SAFETY ALERT

Ride Manufacturer:	Man-Co Mfg., Inc. Dartron Industries, Inc.	Affected Production Dates 1988 through 1999
Ride Name:	Hurricane	Affected Serial #'s: All
Model Number:	All

SAFETY ALERT
BULLETIN # SR-5H-005
PAGE 2 OF 2

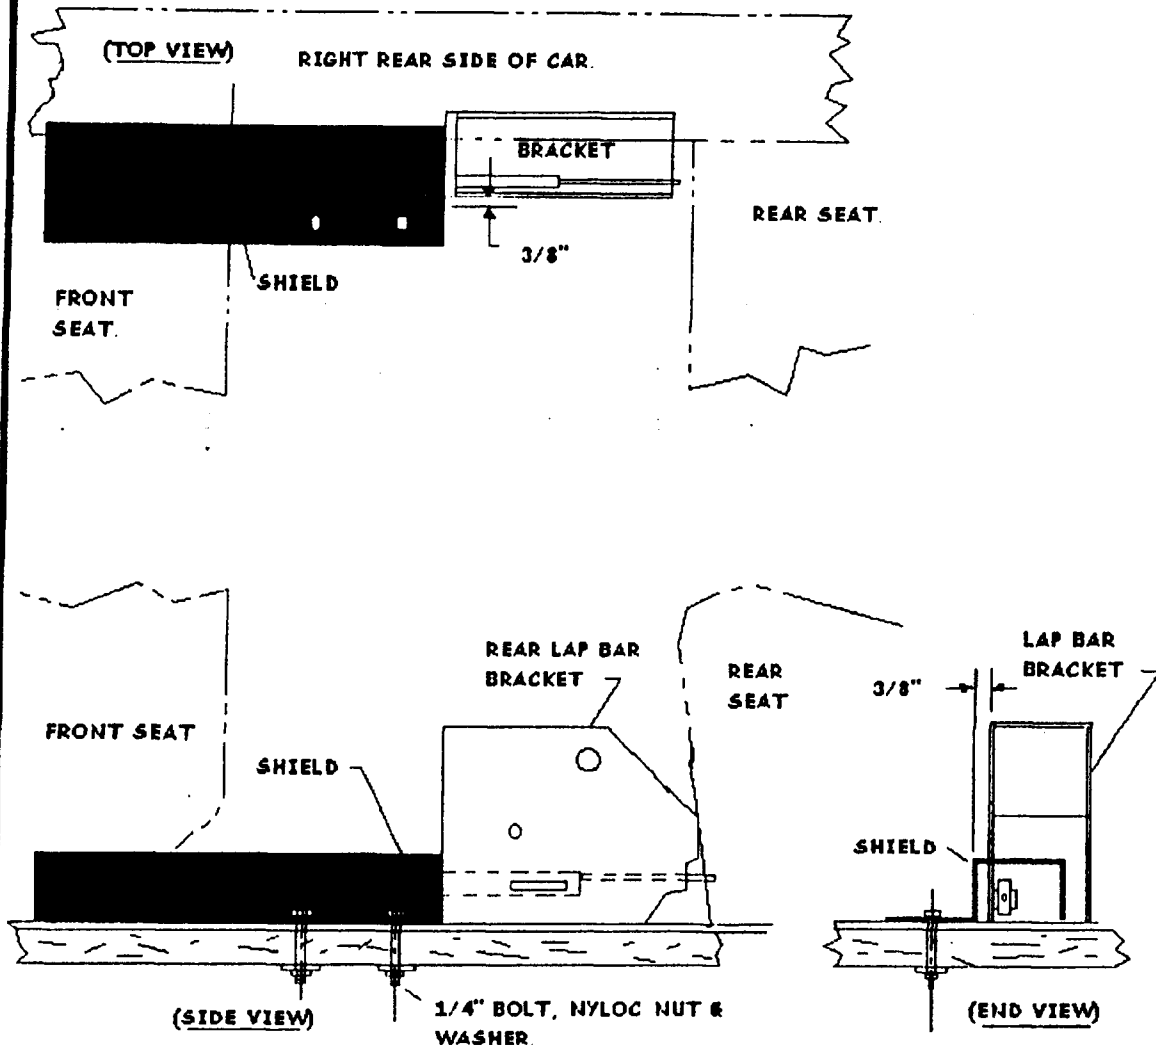
Reason For Release: It may be possible for a passenger in the back seat to release one or both passenger restraints by using a foot to maneuver the restraint release linkage rod.

A shield provided by Dartron should be bolted to the car floor in such a manner that the rod is shielded from the hands and feet of passengers in the back seat of the car.

Action to be Taken: A shield manufactured by Dartron MUST BE installed over the rear seat restraint release linkage rod by owners of Hurricane rides manufactured by Man-Co and Dartron.

Using the holes in the shield flange as templates, drill 2 holes 17/64" dia. through the floor of the car. Install bolts, washers, and locking nuts as shown below. Tighten bolts to no more than 100 in lbs of torque. CAUTION: Do not over-tighten nuts. They should be snug and not dimple fiberglass.

POSITION THE SHIELD SO THAT IT IS AGAINST THE REAR LAP BAR BRACKET AND 3/8" OUT FROM THE FACE OF THE BRACKET (AS SHOWN ABOVE)
